Re: Shade Structures-Kershaw County Aquatics Center Request for Proposals (RFP)

Shade Structures – Kershaw County Aquatics Center Request for Proposals

Addenda February 4, 2021

CAMDEN SHADE PLAN - NO SCALE

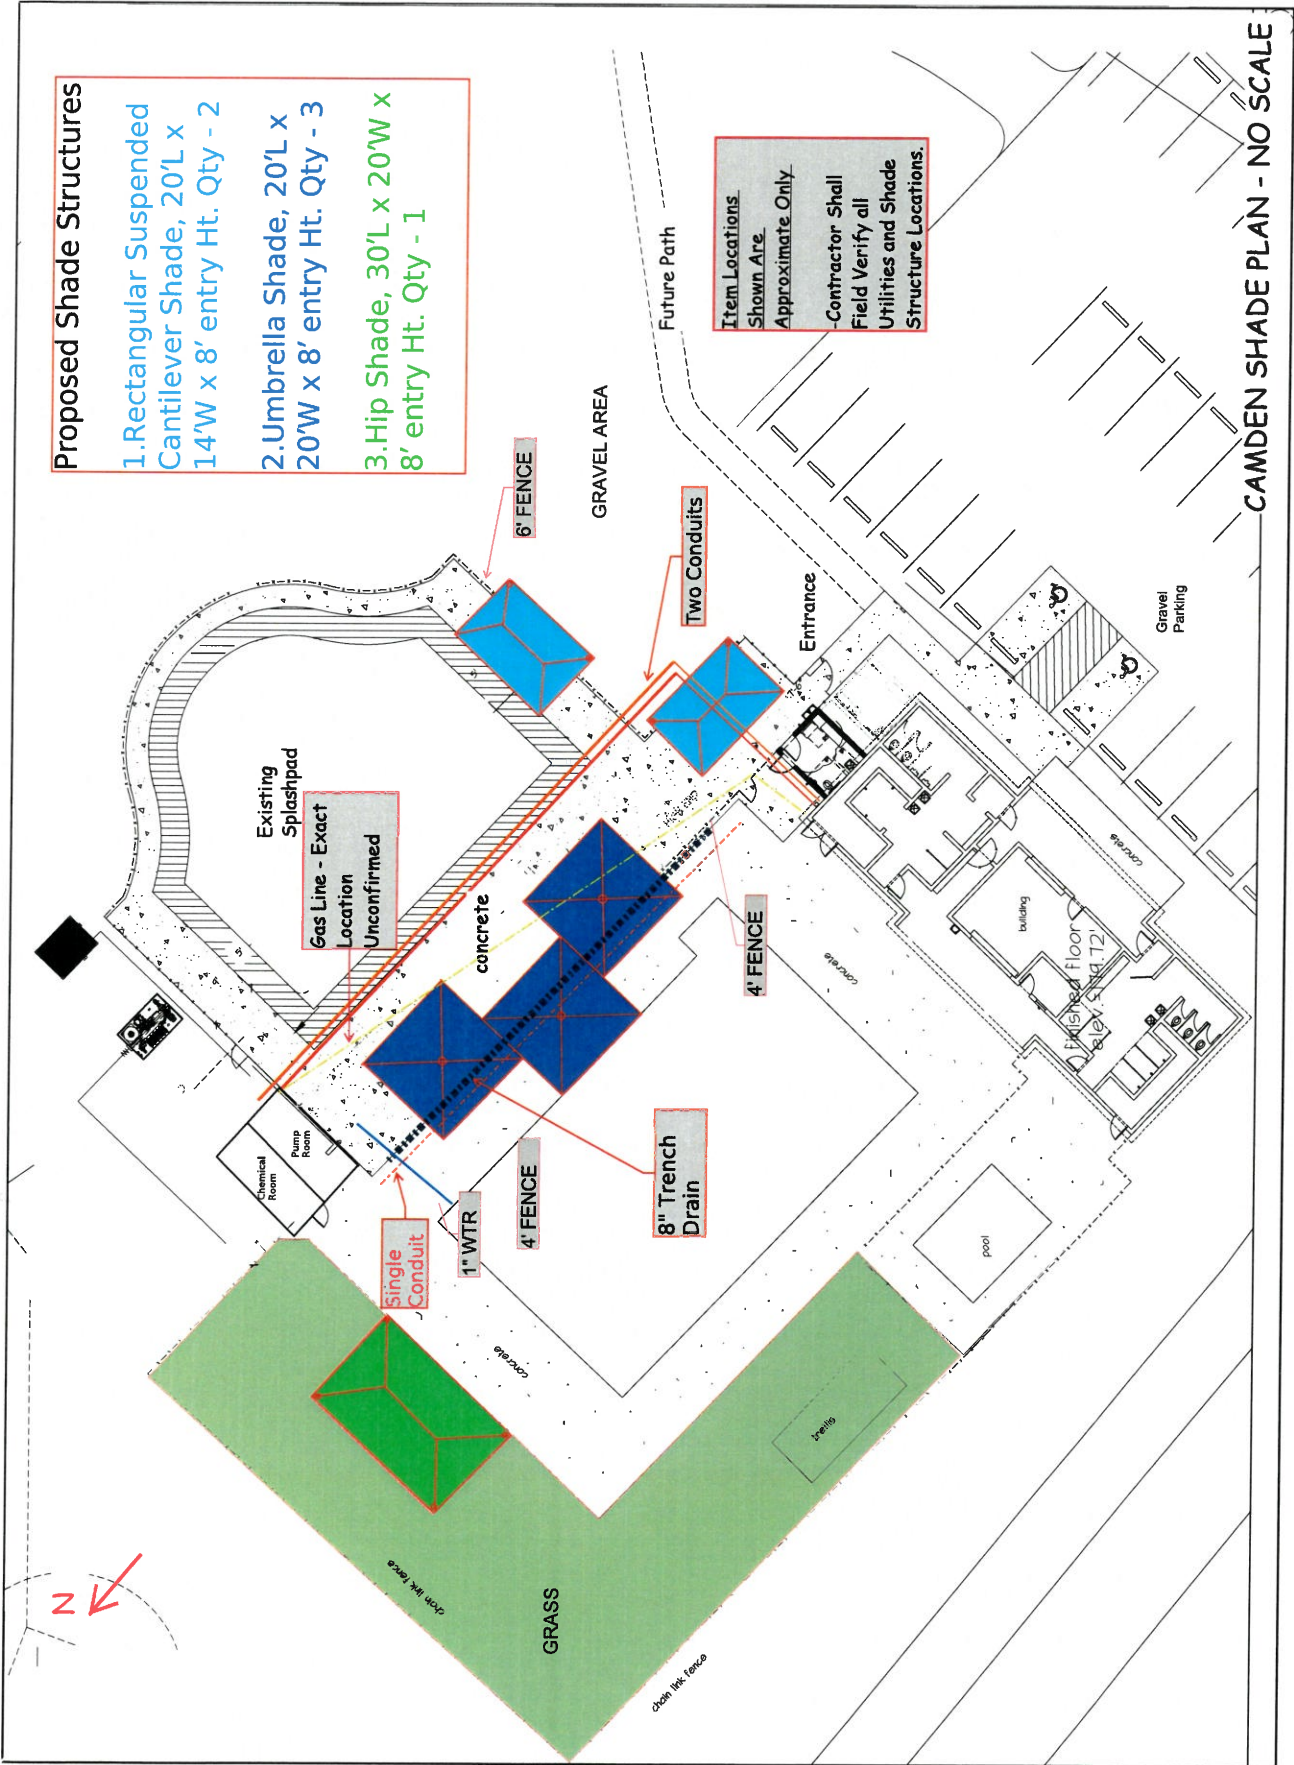
- A. Addenda includes a revised site plan to better delineate proposed shade structures, site facilities, and utility locations, etc. The Contractor will be required to field verify all underground utilities before any excavation. Locations shown are approximate and cannot be guaranteed accurate.
- B. Responses to questions risen by vendors regarding the project since advertisement through February 4, 2021:

Item Locations Shown Are Approximate Only.
 - Contractor Shall Field Verify all Utilities and Shade Structure Locations.
